**MOTORCYCLE  
INDUSTRY  
COUNCIL®**

January 16, 2024

**RE: CARB Proposed On-Highway Motorcycle (HMC) Regulations (Euro 5/ZEM)**

**To:** Eric Barnes, Motorcycle Industry Council  
**From:** Jim Lyons, Trinity Consultants  
**Date:** January 12, 2024  
**RE:** Assessment of CARB's Cost-Benefit Analyses Supporting the Proposed On-Highway Motorcycle Regulations

**Figure 1**

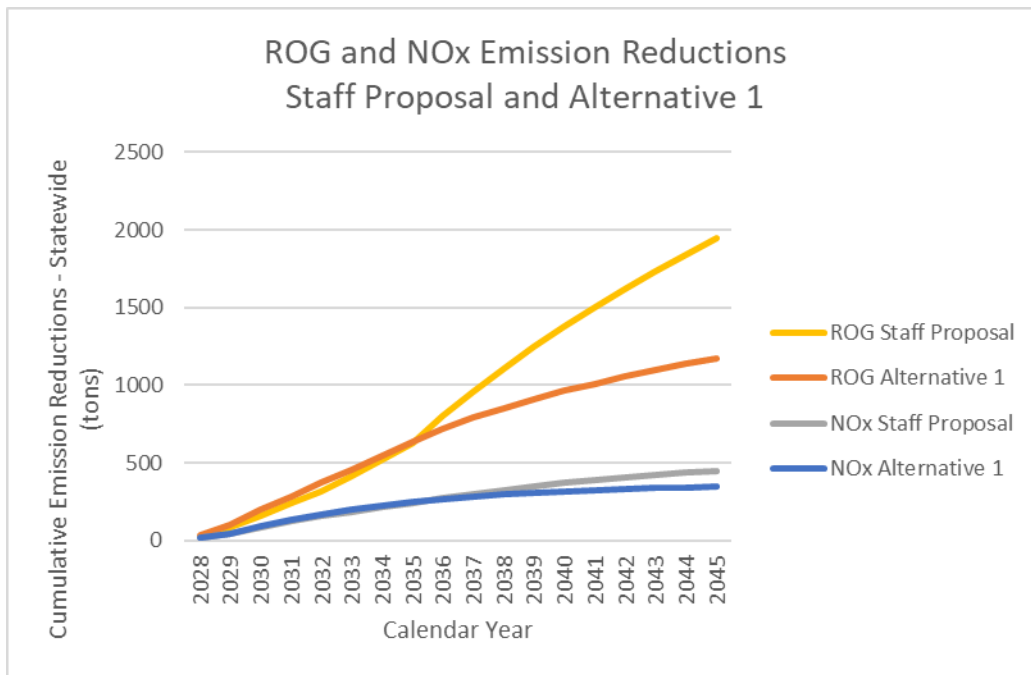
Further detail regarding the relative emission reductions that would be achieved under the proposed amendments and Alternative 1 as well as the magnitude of the assumed increase in ZEM sales that would be driven solely by the proposed amendments can be seen in Figures 1 and 2, respectively. As shown in Figure 1, the differences in NOx reductions between the two are small over the entire period from 2028 through 2045 and the differences are really not distinct until about 2040, 16 years from now. Differences in hydrocarbon emission reductions are more substantial and begin somewhat earlier about 2037.

**Figure 2**

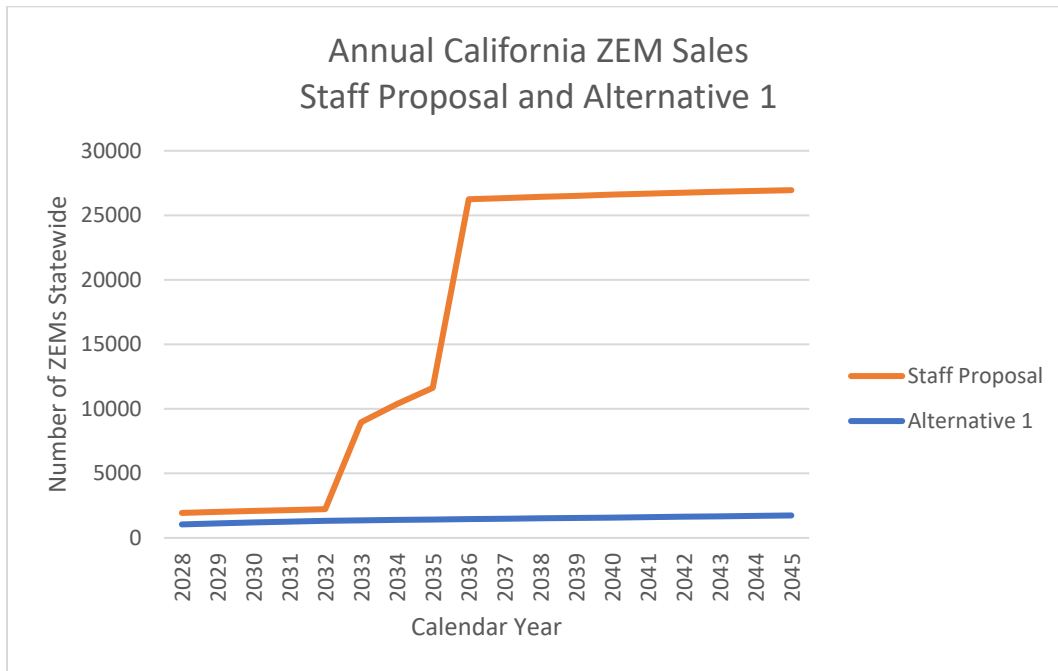
Figure 2 highlights the reason for the differences in the emission reductions of the proposed amendments and Alternative 1. As shown, CARB staff’s baseline assumption for ZEM sales in the absence of the Board’s adoption of the proposed amendments is essentially flat over the entire period from 2028 through 2045. This assumption implies that electric motorcycles will not be produced in meaningful numbers without the adoption of the proposed amendments and is in direct conflict Section 3 of the Staff Report which describes in detail the current state of ZEM offerings and why the ZEM market should be expected to grow substantially over time in the absence of any CARB regulation. Obvious rational for CARB staff’s baseline ZEM sales assumption include that ZEMs will either not be desired by consumers compared to conventional motorcycles for performance reasons or because they are more expensive, both of which conflict with CARB staff’s assessment of the state of the ZEM market in Section 3 of the Staff Report.

Also key in Figure 2 are the two dramatic step changes in ZEV sales that CARB staff assumes will take place in 2033 and 2036 due to the proposed amendments. These imply that the market for ZEMs in California will grow by about 400% in the single year from 2032 to 2033 and then again by about another 200% in the single year from 2035 to 2036. CARB staff provides no discussion as to why it is reasonable to assume that such dramatic changes in the California motorcycle market are feasible other than the fact that they will be dictated by regulation if the proposed amendments are adopted. These types of changes have certainly not been observed in the electric light-duty vehicle market nor are they expected in the future as the result of regulatory drivers.

**Figure 3**

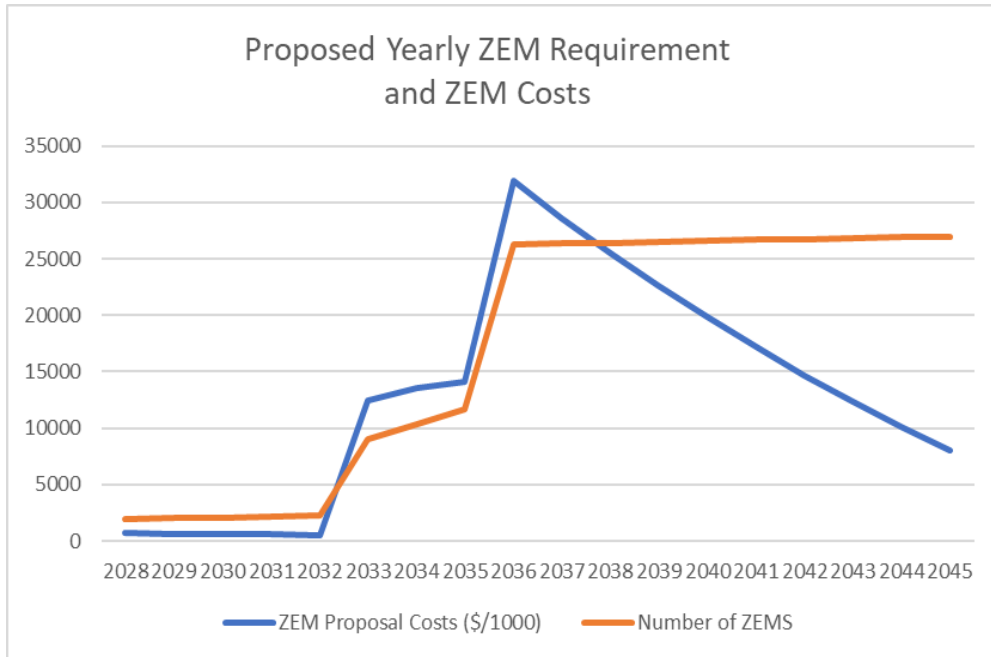
The impacts of CARB staff's assumption on battery costs are shown below in Figure 3 where the assumed ZEM population is plotted along with the assumed cost of those ZEMs over the period from 2028 through 2045. As shown, through 2036, ZEM costs increase dramatically with the increase in ZEM population but then fall dramatically from 2036 to 2045 despite an almost constant level of assumed ZEM sales.

**Figure 4**

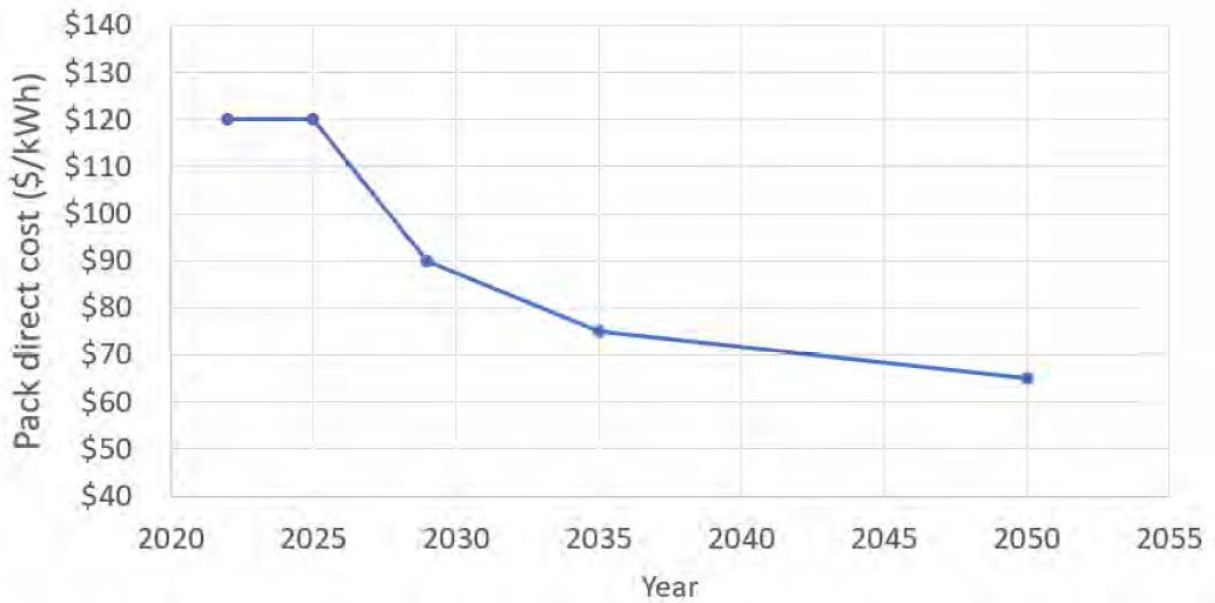
In supporting the assumption that battery costs will fall by 5.78% per year, CARB staff again cites work performed by the agency related to the ACC II regulation. However, that work, (which in itself relied on highly optimistic assumptions regarding battery costs developed by the National Academies of Science that applied only through 2030), extended the 5.78% per year only through 2035 not through 2045. The first problem with CARB staff's assumption here is the failure to recognize that at some point battery costs must level off – open ended extrapolation of CARB staff's assumption of a 5.78% per year reduction in battery costs means that CARB staff ultimately believes the cost of batteries will approach zero, which is clearly unreasonable. The reality that battery cost reductions must level off can be seen in U.S. EPA projections for battery costs for light-duty vehicles that were published as part of that agency's on-going rulemaking regarding GHG emission standards. This can be seen for example in Figure 2-25 of the Draft Regulatory Impact Analysis (DRIA) for that rulemaking<sup>3</sup> which is reproduced as Figure 4 below. As shown, battery costs decline very slowly

during the period from 2035 through 2045 (~1% per year) following a rapid initial decrease from 2025 to 2028 and a more moderate (~2.4% per year) decrease from 2028 to 2035.
